Camden Local Planning Panel

20 September 2022

**SUBJECT: DA/2021/1220/1 - CONSTRUCTION OF THE ORAN PARK TAVERN WITH ASSOCIATED SITE WORKS - 2-4 PORTER STREET, ORAN PARK**

**Figure 9** – Floor plan of the proposed development. Areas outlined in red are classified as non-public areas and/or ancillary to the premises in the ‘Letter of Advice’, prepared by McLaren’s Traffic Consulting.

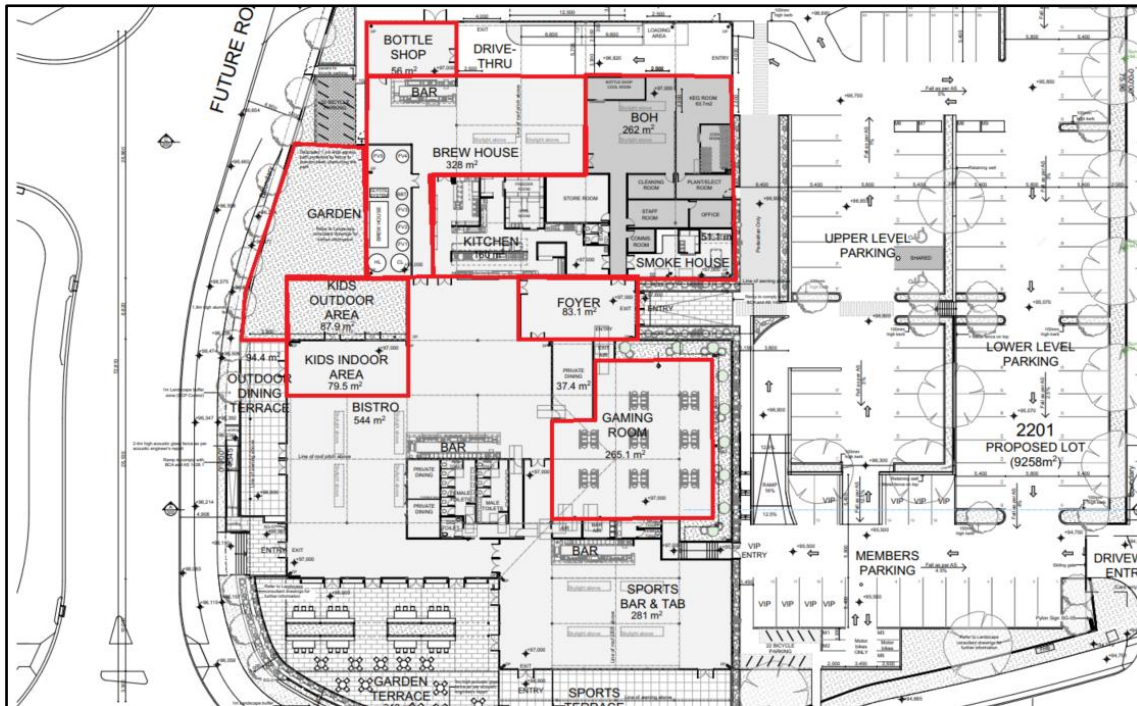
Further, the remaining areas (including the Brewhouse, Gaming Room, Garden, Back of House, Smokehouse, Bottle Shop and Kids Play Area) were noted to be ancillary and/or non-public areas within the premises (see **Figure 9** below). The letter justifies that these areas do not directly generate patron car parking demand and therefore the proposed car parking rate should not apply.

Council’s Traffic Engineer and an external/independent traffic expert engaged by Council have assessed the parking submissions prepared by John Coady Consulting Pty Ltd and McLaren’s Traffic Engineering and undertaken an analysis of the car parking demands of the development. Several concerns have been raised in relation to the following matters:

**Figure 10** – Floor plan of the proposed development. Areas outlined in green relate to entrances within the gaming room. Areas outlined in red relate to entrances within Brewhouse.

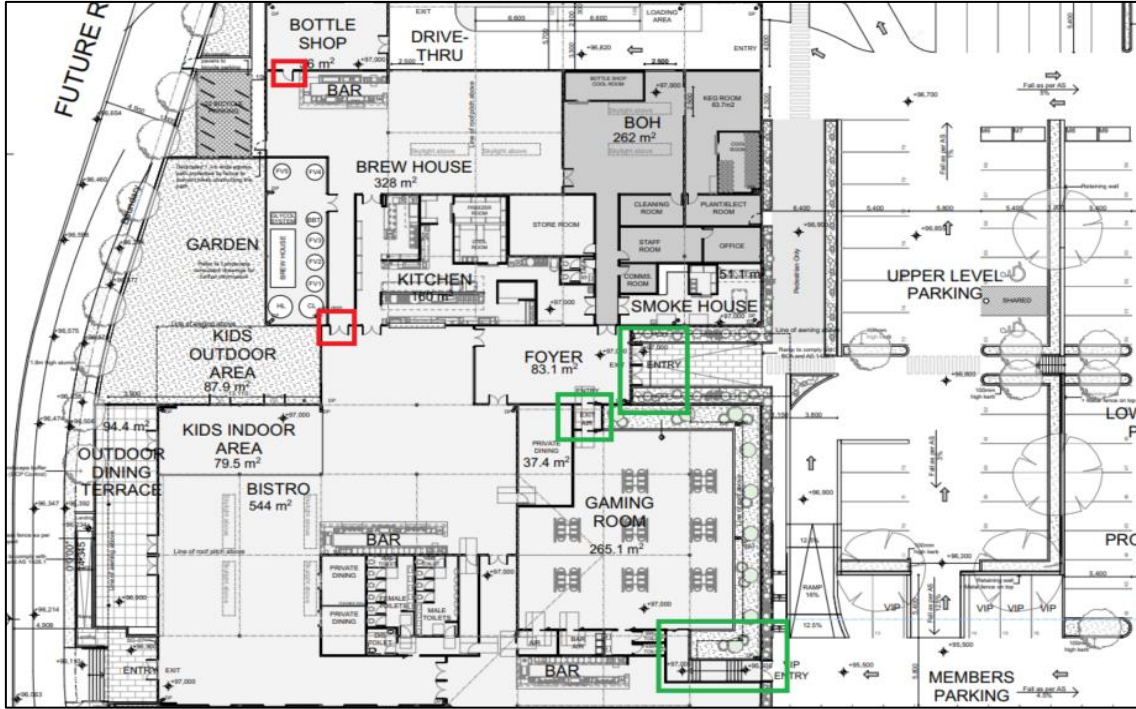
- The Brewhouse includes a bar and two separate pedestrian entrances that directly connect to the bistro and bottle shop (see areas outlined in red in **Figure 10** below). A separate staff entrance is also proposed outside the kitchen that also connects directly to the Brewhouse (via a similar route). Therefore, the need for two separate pedestrian entrances into this area is being questioned. It is also noted that the Brewhouse can easily be made available for public use at any time without further development consent, and this area was previously identified as public floor area.

At the time when the DA was publicly notified, the kids indoor play area formed part of the bistro floor space. It appears this change was made to lower the number of car parking spaces (in accordance with the proposed rate in the Traffic Assessment) required to accommodate the development (see **Figures 11** and **12** below). Given that the kids indoor play area can easily form part of the bistro without requiring any modifications, it is considered that this space should also be considered as public floor area.

**Figure 14 – The extent of the variation proposed regarding the landscape setback.**

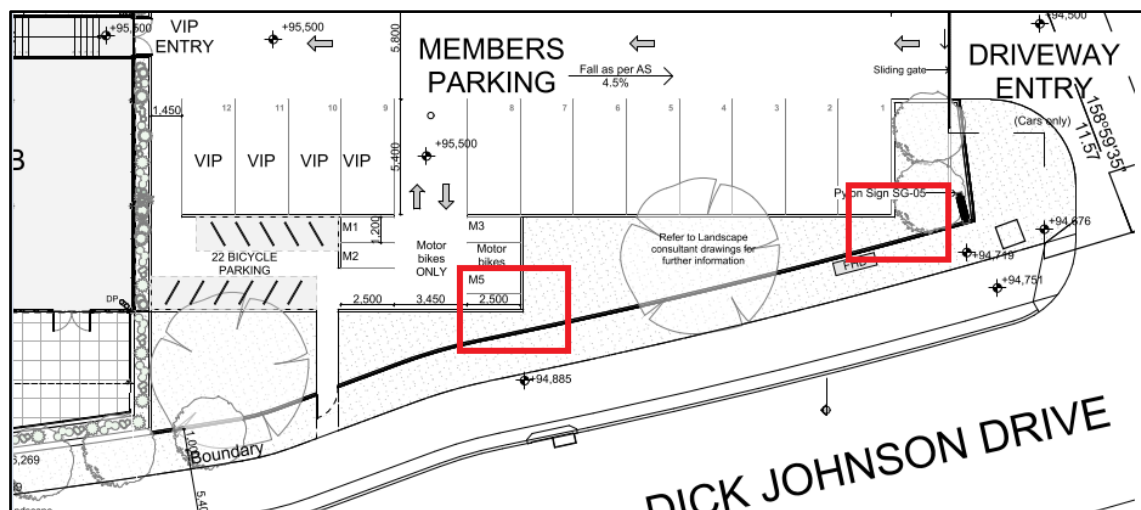
*Variation Details – A 1.8m high black open palisade style fence along the car parking boundary only (fronting Dick Johnson Drive) is sought, at a 1m landscape boundary setback. Boundary fencing is not sought for the remaining front setback (Dick Johnson Drive). The development proposes a modulated landscape buffer, ranging from 1.2m to 7.5m in front of the car parking area (via Dick Johnson Drive) and will therefore result in a non-compliance by up to 1.8m. The extent of the non-compliance is shown below in Figure 14.*

Council staff have assessed the variation in detail and assess that it can be supported for the following reasons:
